Response to Submissions Report

Daroobalgie Solar Farm

21 November 2022

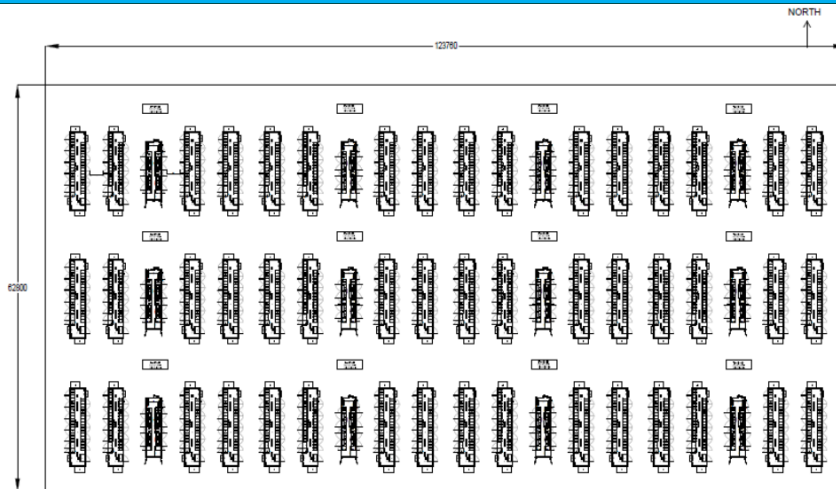
Location of Artefacts	<p>Clarification is required on the location of artefacts within their respective site boundaries and in relation to the project area and proposed impacts. Several sites appear to be outside of the proposed SSD area and/or impact area. If these sites are not within the project area but may be harmed through construction or other works then these sites may require an Aboriginal Heritage Impact Permit (AHIP) before any harm could occur.</p>	<p>The location of artefacts or groups of artefacts within the site areas has been added to Figures 6.2A-B in the ACHA report.</p> <p>All sites outside the CDA area will be demarcated by temporary fencing as per the recommendations in Section 10.2 of the ACHA to ensure their protection.</p> <p>These sites are:</p> <ul style="list-style-type: none"> – DSF AS9 – DSF AS8 – DSF AS7 – DSF AS6 – DSF IF6 – DSF IF5 – DSF IF4
